4309 A

SEDBERGH TX Mk. 1 LIGHT GLIDER

GENERAL ORDERS AND MODIFICATIONS

DRG. NO A.P.4309 A /D.1 / 51

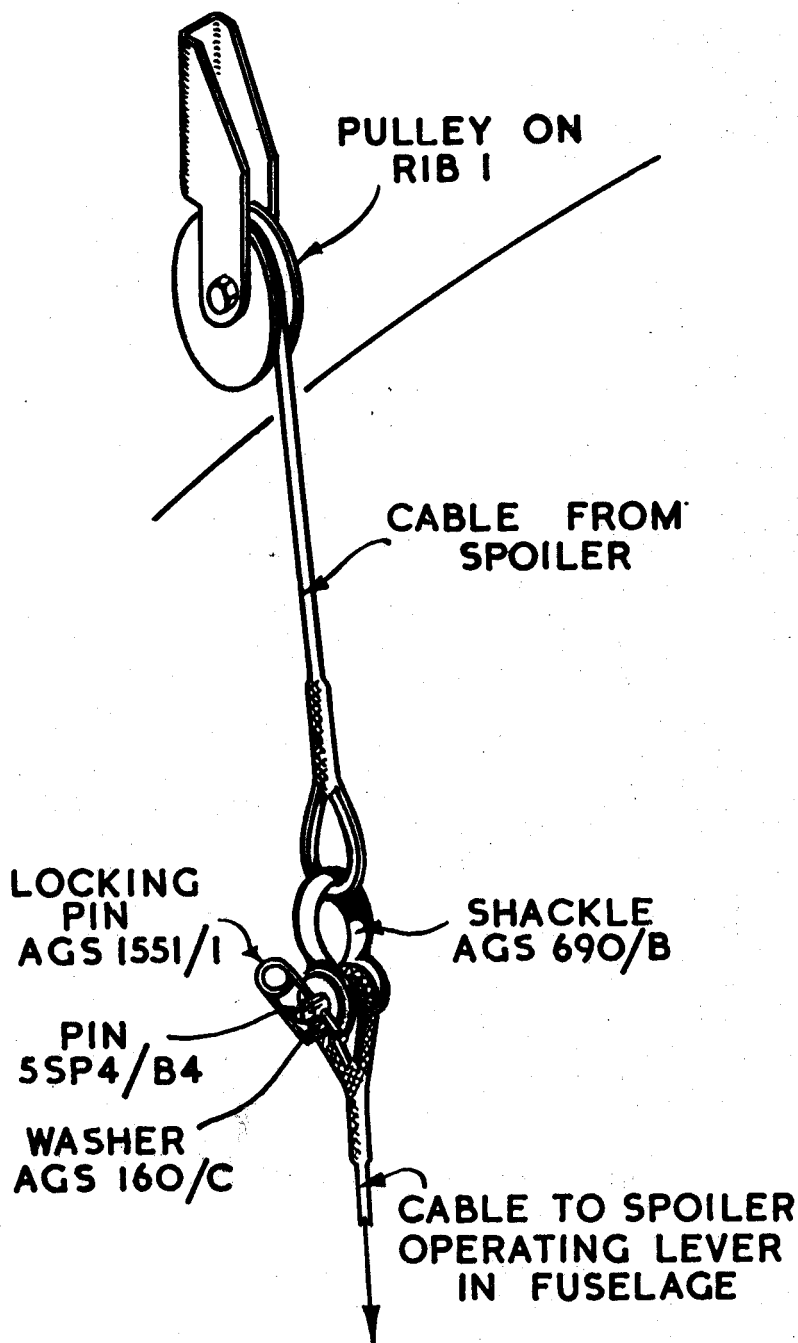
1. This modification has been necessitated in consequence of reports of straightening of the spring loaded clips, joining the spoiler cables between the fuselage and wings, and provides for replacement of the clips with shackles, Part No. A.G.S.690/B. The modification will take approximately $\frac{1}{4}$ man-hour to fit.

(2) Disconnect spoiler cables at spring clips and remove spring clips. Insert shackles, Part No. A.G.S.690/B, through ends of cables from wing and connect up as shown in the drawing.

DRG. N° A.P4309A / D.2 / 51
SHEET 2

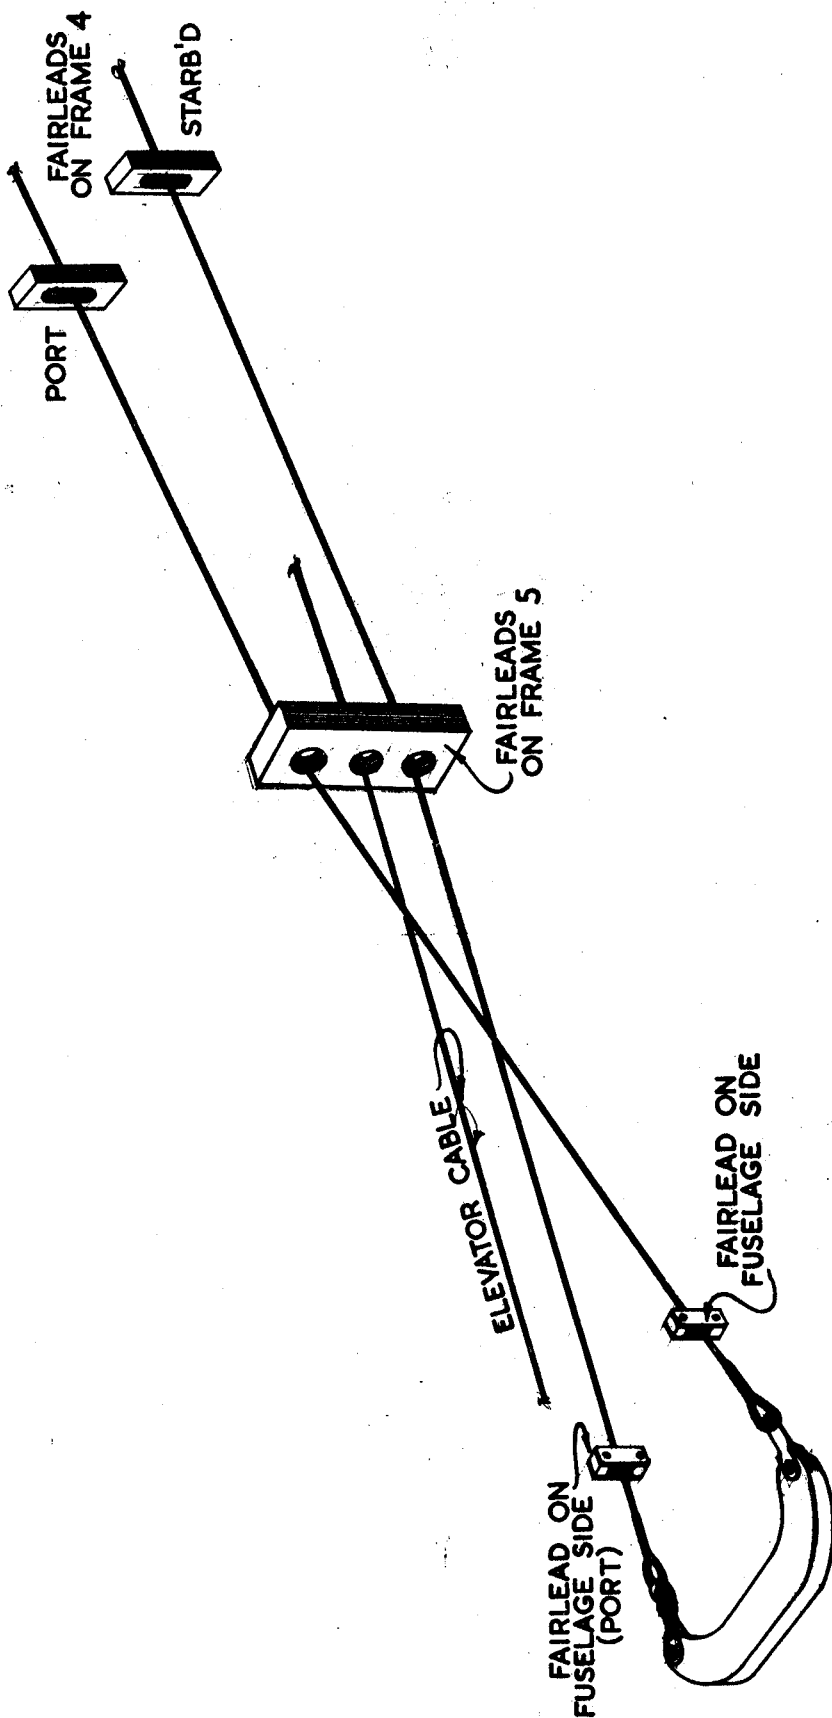
1. This modification has been necessitated by the high rate of wear occurring in rudder cables and makes provision for straightening the cable runs and altering the material for the cable. The work will take approximately 4 man-hours.

(15) Remove the three positioned fairleads of frame 5, which takes rudder and bottom elevator cables, and reposition on rear face of frame, using same attachment holes; fix with 4 B.A. screws A.16Y/13B and stiffnuts, A.G.S. 2001/B/1. Thread bottom elevator

cable through centre hole in fairlead, as shown in sheet 2 of the drawing, and reconnect to bottom of elevator horn, using existing clevis pin and new split pin, A.G.S.784/2.

(18) Pull cable down rear fuselage, by means of cords, to fairlead on frame 5. Thread cable from starboard side through top hole in fairlead and cable from port side through bottom hole, as shown in sheet 2 of the drawing.

DRG. N° A.P.4309A /J.1 /51

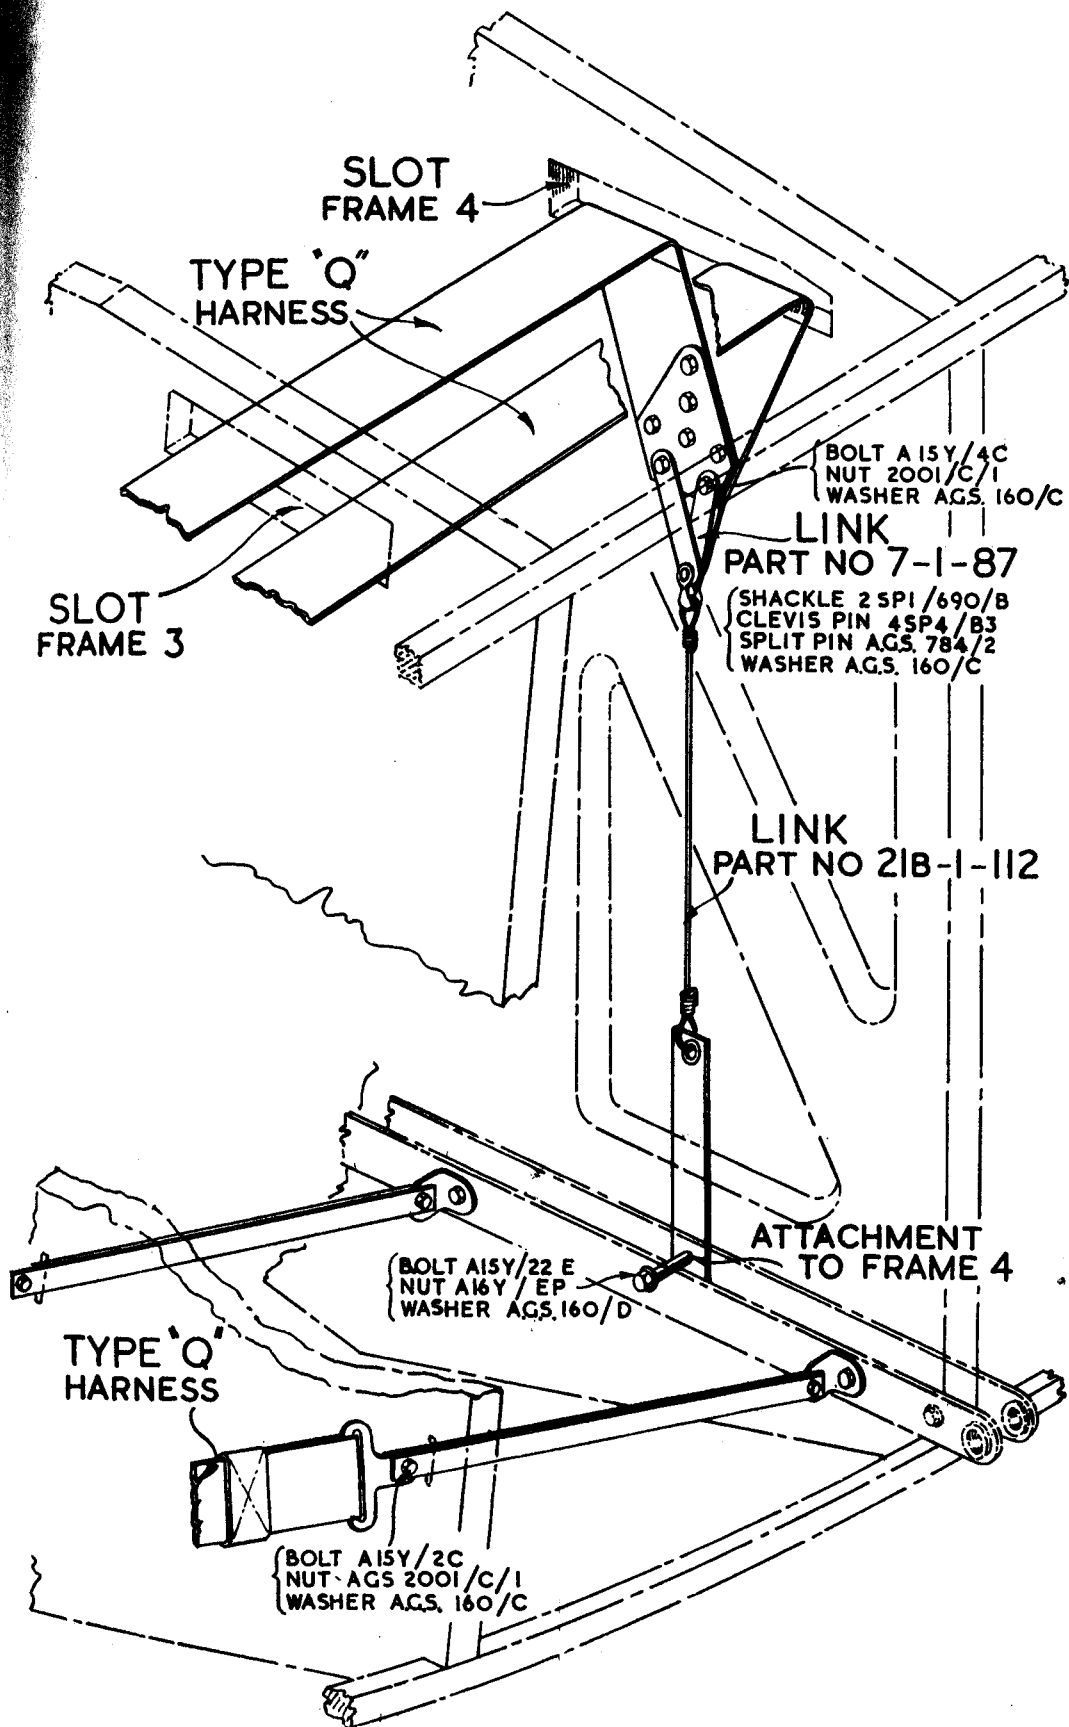
1. This modification has been necessitated by the requirement to replace the Sutton harness, and makes provision for the incorporation of Harness, type Q. The work will take approximately 4 man-hours.

(2) Assemble harness shoulder straps to link up Part No. 21B-1-112, as shown in the drawing.

(3) Assemble shoulder straps into fuselage by threading links through harness slots in frames 3 and 4, and fixing links to strut attachment fittings with $\frac{1}{4}$ in. B.S.F. bolt, nut and washer, as shown in the drawing. Lock nut by pipping bolt in three places.

(4) Assemble lap straps to fuselage by fixing end lug to links at frame 3, as shown in the drawing. Ensure when assembling lap straps, to see that the release is positioned in such a way that the word "FASTEN" is at the top.

DRG. N^o A.P.4309A /J.1 /51

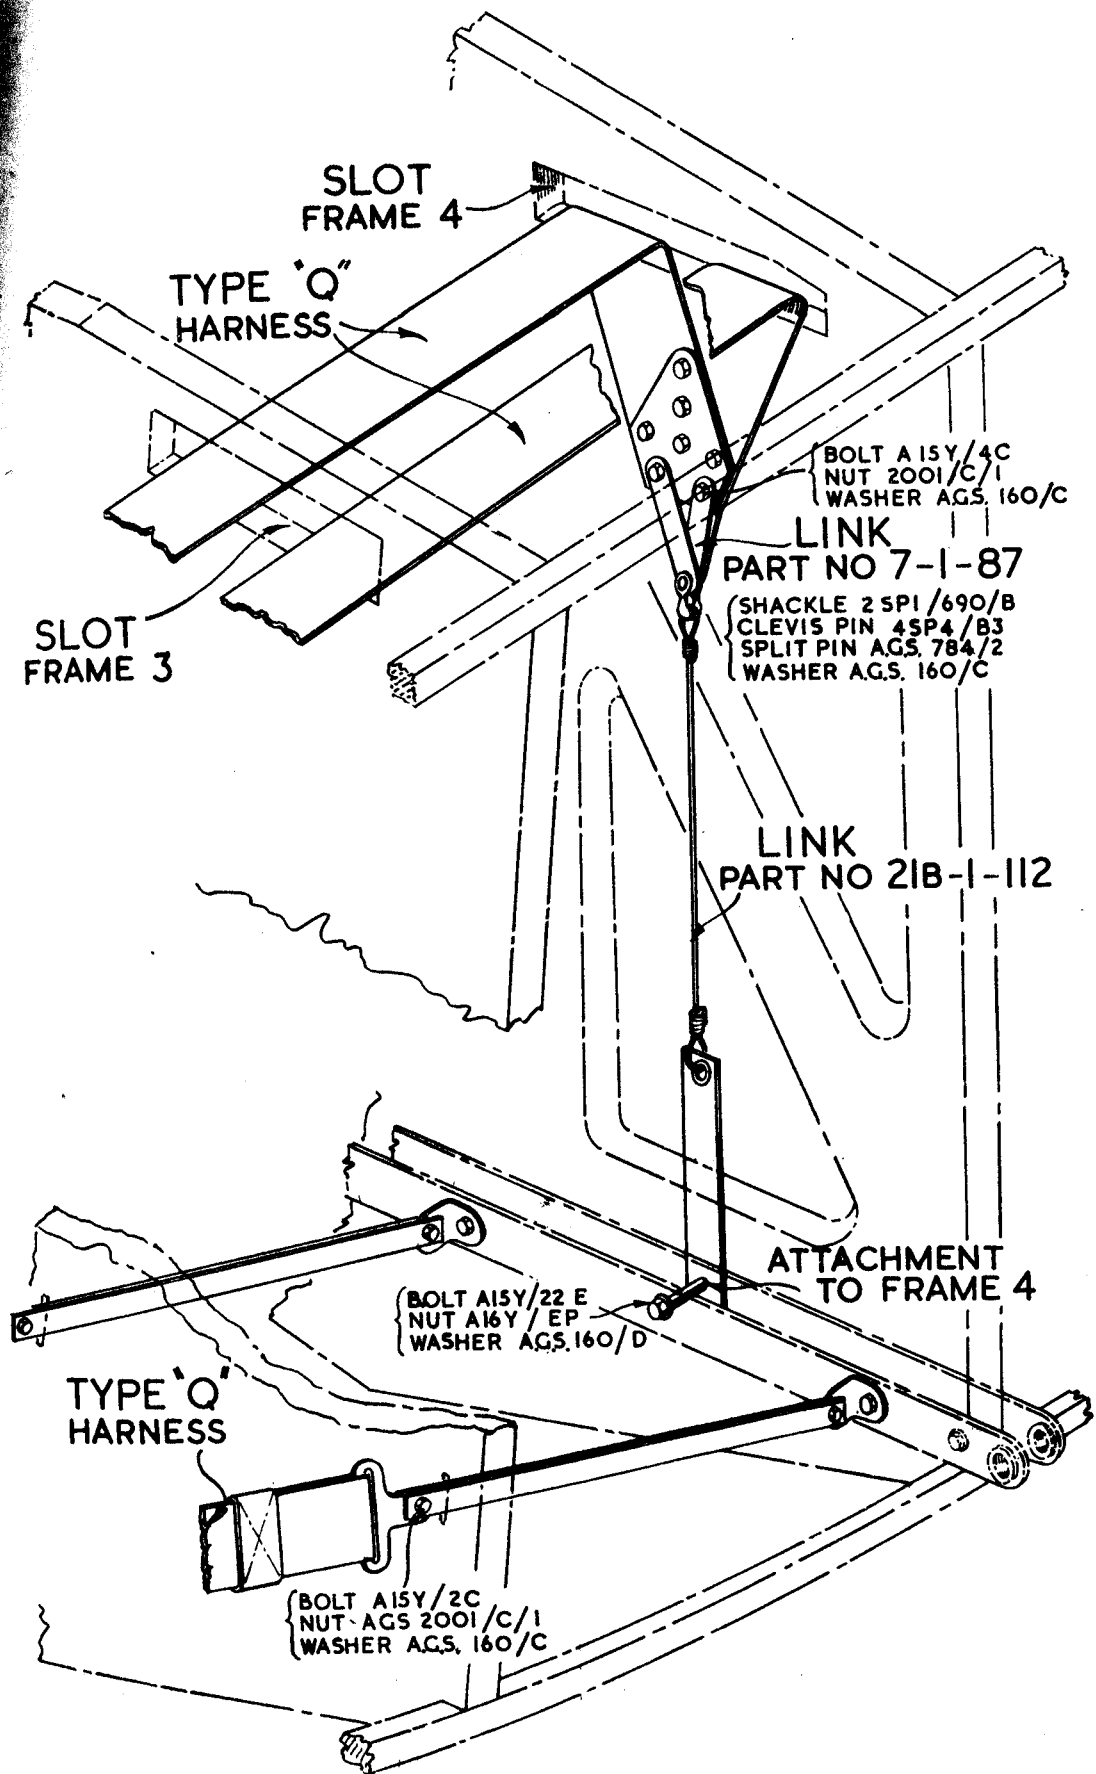
1. This modification has been necessitated by the requirement to replace the Sutton harness, and makes provision for the incorporation of Harness, type Q. The work will take approximately 4 man-hours.

(2) Assemble harness shoulder straps to link up Part No. 21B-1-112, as shown in the drawing.

(3) Assemble shoulder straps into fuselage by threading links through harness slots in frames 3 and 4, and fixing links to strut attachment fittings with $\frac{1}{4}$ in. B.S.F. bolt, nut and washer, as shown in the drawing. Lock nut by pipping bolt in three places.

(4) Assemble lap straps to fuselage by fixing end lug to links at frame 3, as shown in the drawing. Ensure when assembling lap straps, to see that the release is positioned in such a way that the word "FASTEN" is at the top.

DRG. N° A.P. 4309 A / K. 1 / 55
SHEET I

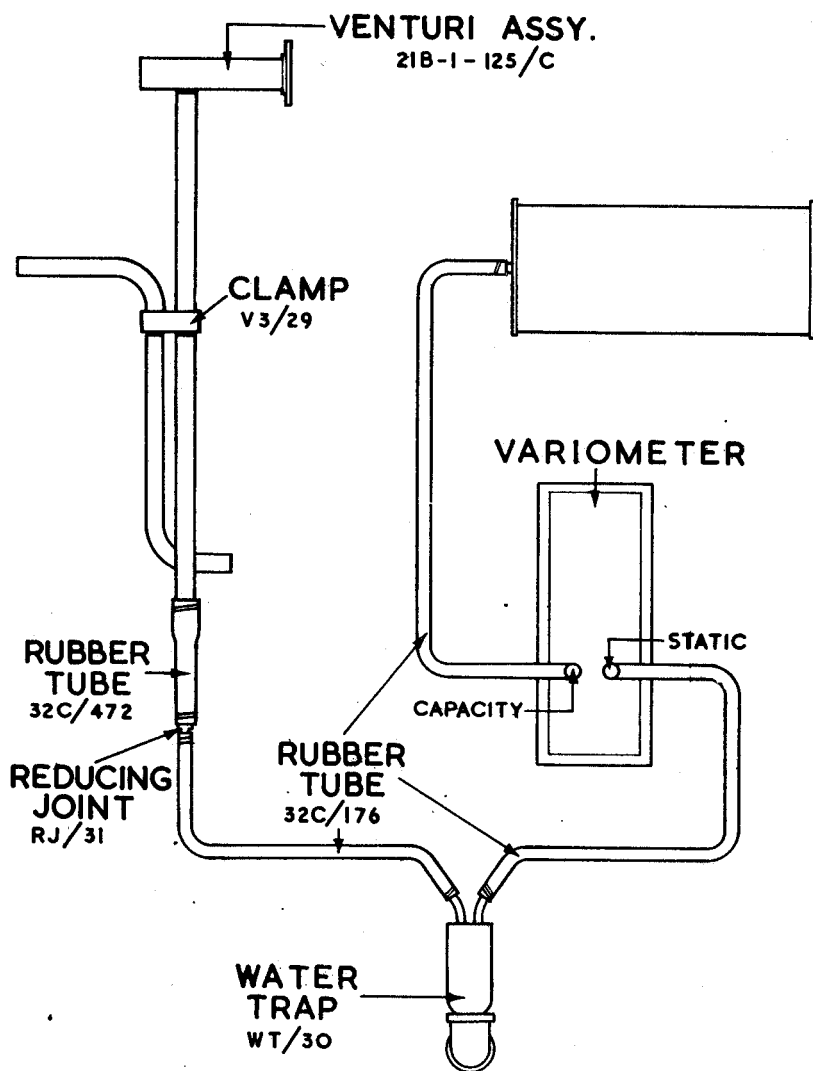
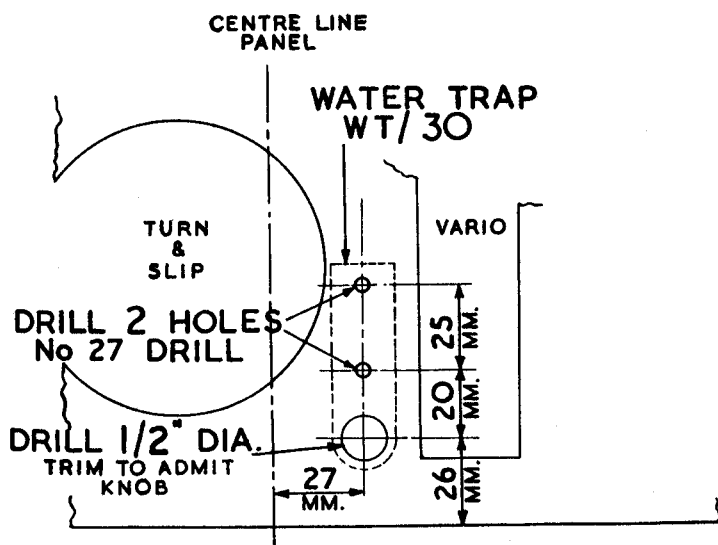
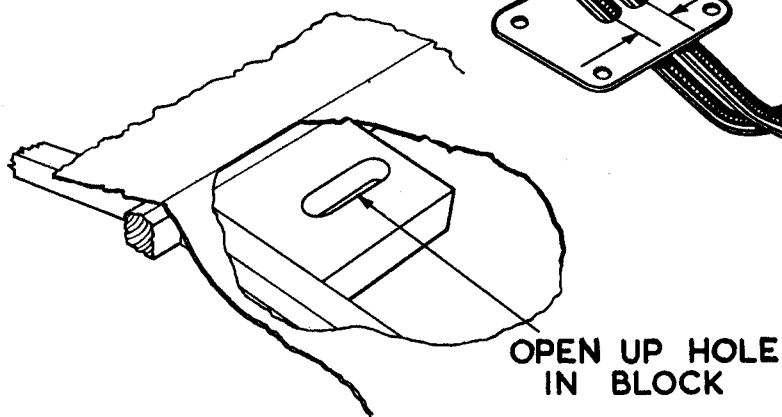
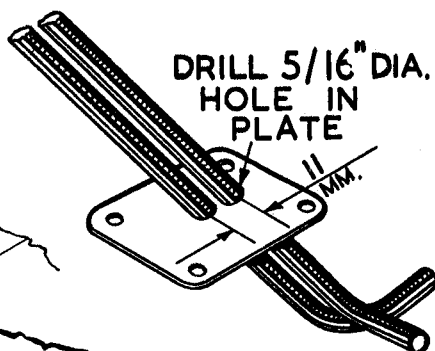
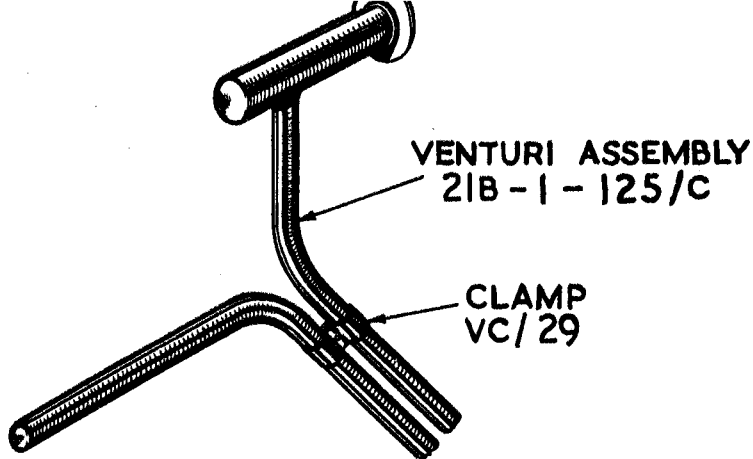
This modification has been introduced to improve the indications on the Variometer and makes provision for the introduction of a total energy venturi which is attached to the pressure head and connected to the static side of the variometer.

(2) Drill $\frac{5}{16}$ in. dia. hole in attachment plate of pressure head as shown in Sheet 1 of the drawing to take tube from venturi.

(3) Open up hole in pressure head attachment block in fuselage nose to take venturi tube as shown in Sheet 1 of the drawing.

(5) Fix venturi, Part No. 21B-1-125/C to pressure head as shown in Sheet 1 of the drawing.

(6) Drill instrument panel to take water trap, Part No. WT/30 as shown in Sheet 1 of the drawing, and fix water trap using the screws supplied with the part.

DRG. NO A.P. 4309 A / K. 1 / 55
SHEET 2

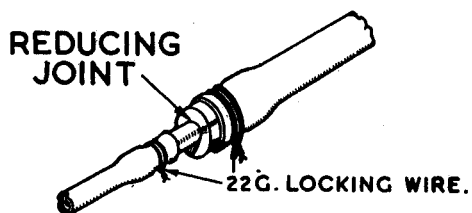
(7) Cut 6 in. length of $\frac{1}{4}$ in. outside dia. \times $\frac{1}{8}$ in. inside dia. rubber tube (Stores Ref. 32C/176) and connect static side of Variometer indicator to starboard side of water trap as shown in Sheet 2 of the drawing.

(8) Cut 6 in. length of $\frac{1}{2}$ in. outside dia. \times $\frac{1}{4}$ in. inside dia. rubber tube (Stores Ref. 32C/472) and insert large end of reduction joint, Part No. RJ/31 in one end and connect the other end to venturi tube as shown in Sheet 2 of the drawing.

(10) Lock all ends of rubber tubes connected to variometer indicator, water trap and venturi tube by taking two turns of 22 s.w.g. locking wire (Spec. D.T.D.189) round the rubber tube and twisting ends until the wire is tight as shown in Sheet 2 of the drawing.
